# DEVELOPMENT REVIEW BOARD REPORT

**87-DR-2005**  
**Lowe's Home Improvement Center**

Request approval of a site plan and elevations for construction of a new home improvement center.

## **Stipulations for Case: Lowe's Home Improvement Case 87-DR-2005**

LANDSCAPE PLAN  
0' 20' 40' 60'

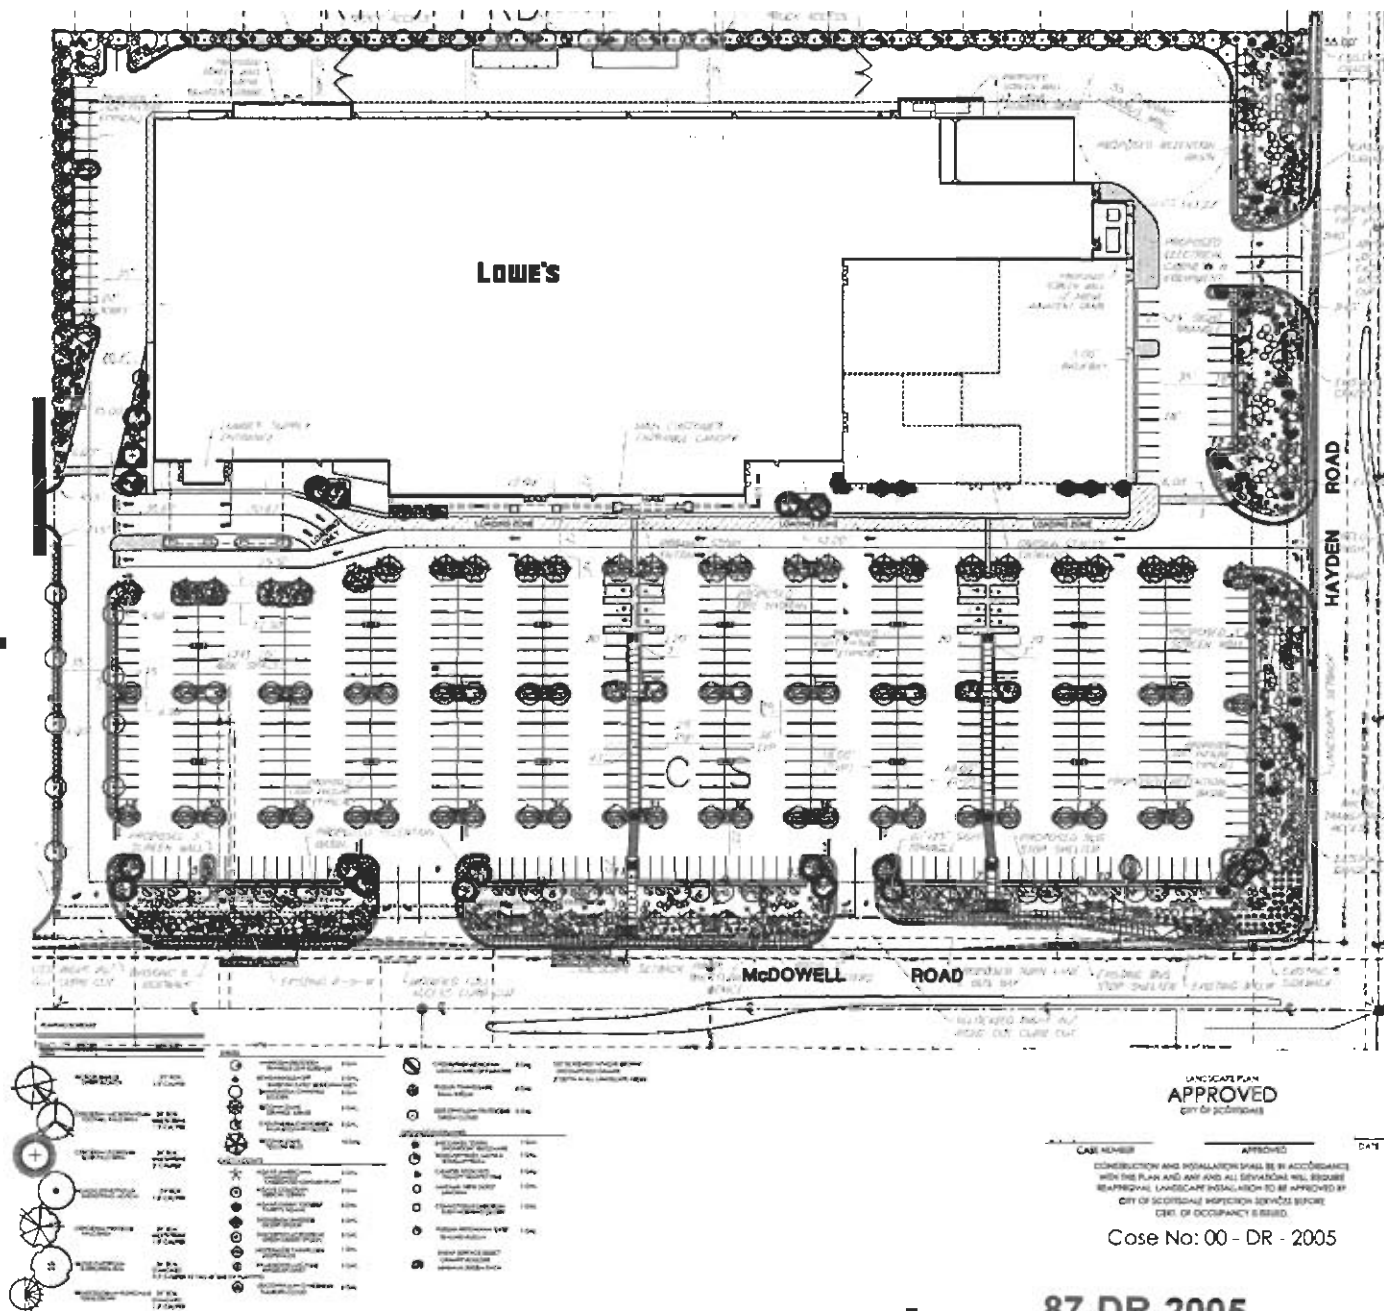
15. *Any trees that are provided, other than the Zoning Ordinance required mature trees, shall have minimum tree size of a 2-inch single trunk diameter, or 1 inch average multi-trunk diameter.*
16. *An additional 25 trees shall be planted in diamond shaped planter areas in the parking lot, spaced evenly between the light poles and proposed landscape islands. The dimensions for these planting areas shall be not less than 4 feet by 4 feet; and the minimum tree planting shall be 36-inch box at the time of planting.*

**EXTERIOR ELEVATIONS**

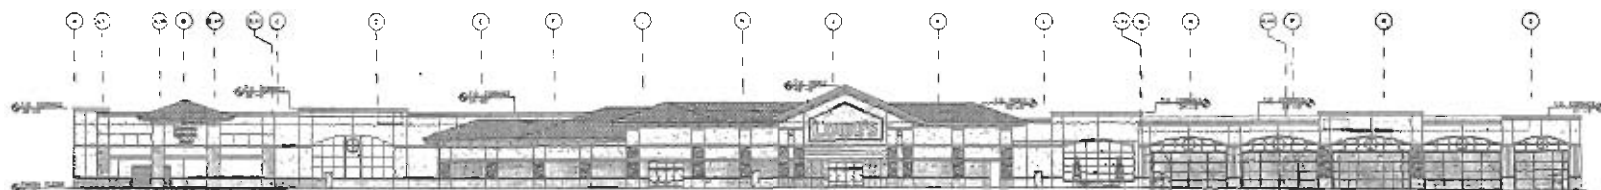
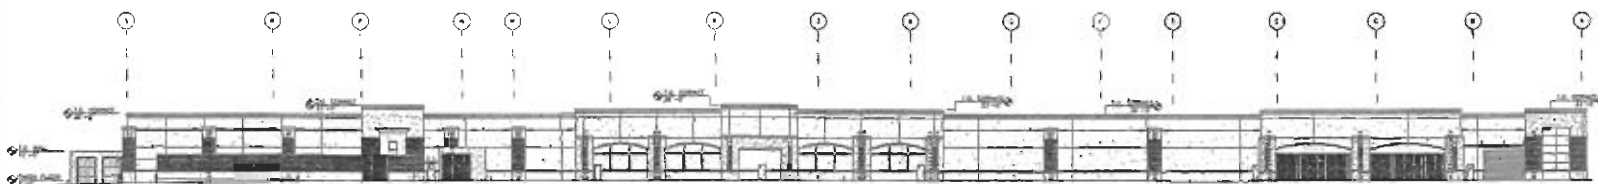
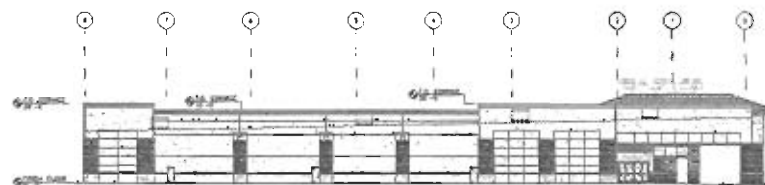
11. The hip roof, East and West of the entry with the Lowe's logo, indicated on the building elevations submitted by Kurt D. Reed Associates, INC. with a date provide on the plans by City Staff of 11/28/05 shall be eliminated, and replaced with a parapet element, or lowered to a maximum height of 36 feet.
